# ***Clyde Waste Transfer Terminal***

*Part 3A Modification  
Assessment  
(DA 205-08-01 MOD 5)*

April 2019

**Figure 4** | Current access arrangements from Parramatta Road

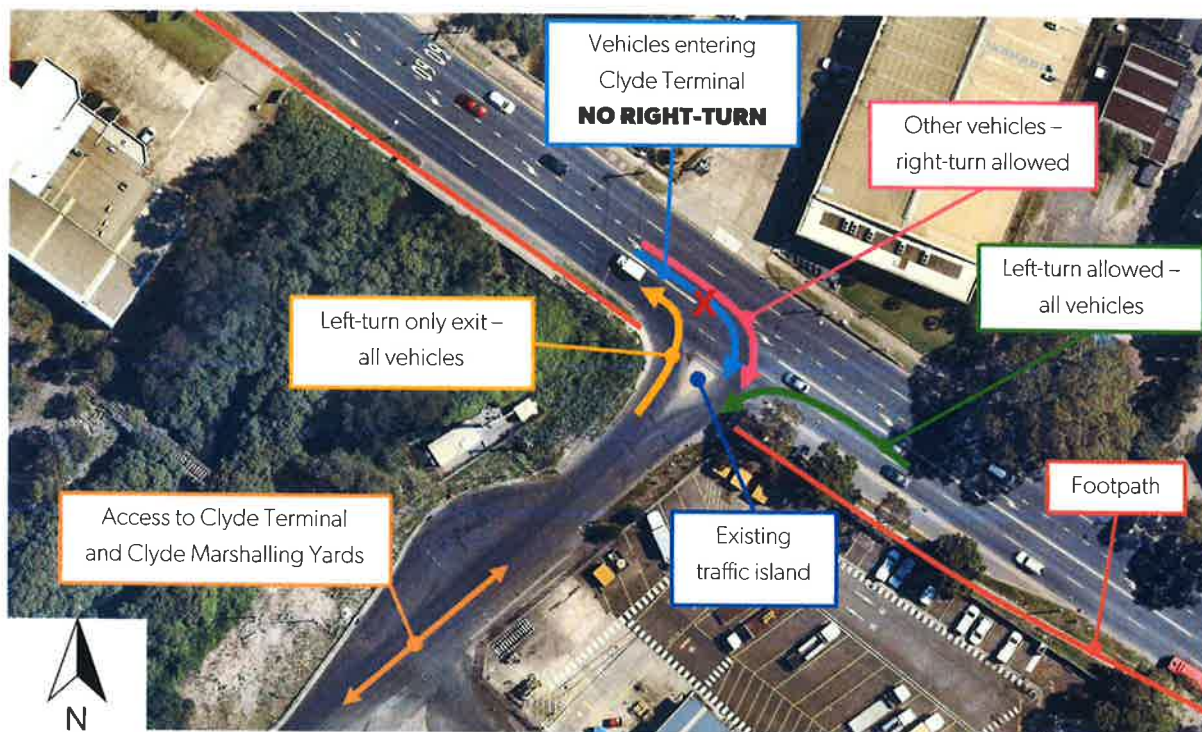
There is a dedicated right-turn lane on Parramatta Road for movements into Rawson Street that also serves as a right-turn lane into the Clyde Terminal access road. The right-turn lane has recently been upgraded and extended by RMS (See **Figure 4**).

The modification seeks to remove the right-turn restriction on all vehicles entering the Clyde Terminal from Parramatta Road. The Proponent has advised that, despite the restriction, many waste trucks entering the Clyde Terminal from the west are already turning right from Parramatta Road rather than taking a detour to enter via a left turn. The Proponent maintains it is safe to make the turn because of the long sight lines on Parramatta Road and the dedicated right-turn lane provided.

As described in Section 5 above, for safety reasons Council and RMS originally did not support the removal of the right-turn restriction, however RMS later revoked its objection due to its recent upgrade works on Parramatta Road. The Department notes there was a pedestrian fatality involving an existing truck at the intersection in 2014.

It would appear from swept path drawings provided by Veolia that larger-size trucks may make contact with the kerb during the existing right-turn, however the Department notes that the largest size vehicle entering the Clyde Terminal via a right-turn would be a rigid 12.5 metre waste truck.

Council maintained its strong concerns regarding the suitability of the existing intersection for trucks turning right, particularly with regard to pedestrian safety. Council required the intersection to be re-designed and reconstructed to include pram ramps and a pedestrian refuge island, as well as to accommodate the largest vehicle using it (B-double trucks). Council specified these upgrades should be at Veolia's sole expense. The Proponent provided further information and various concept designs of intersection upgrades showing all turns in and out of the private access road for different truck sizes. These concept designs highlighted the potential need to adapt or remove the existing traffic island and move in-ground services to accommodate larger truck movements. Internal discussions continued at Council during 2018 and, whilst there was no agreement on the final intersection design, on 17 February 2019 Council advised the Department in writing it was now satisfied in principle that the intersection upgrades may be undertaken to accommodate the largest service vehicle accessing the site, as required by the Proponent for the development (i.e. 12.5 m rigid waste truck turning right and semi-trailers turning left only).

Pedestrian and road user safety are of high importance to the Department and due consideration has been given to all information provided by the Proponent, as well as the professional opinions of RMS and Council. On balance, the Department is satisfied that right-turns into the Clyde Terminal from Parramatta Road can be undertaken safely, subject to appropriate intersection design. The Department has therefore proposed a condition of consent that permits the right-turn from Parramatta Road, however requires the final design and construction of the intersection works to be completed in consultation with and to the satisfaction of Council and RMS before any vehicle may turn right into the Clyde Terminal. The Department particularly notes that the intersection design must accommodate semi-trailers turning left in and left out of the Clyde Terminal to Parramatta Road, however the right-turn may be designed for a maximum size of 12.5 m rigid trucks.

To support intersection safety, the Department has also included a condition requiring a road safety audit to be undertaken within 6 months of commencement of right-turn movements at the upgraded intersection.
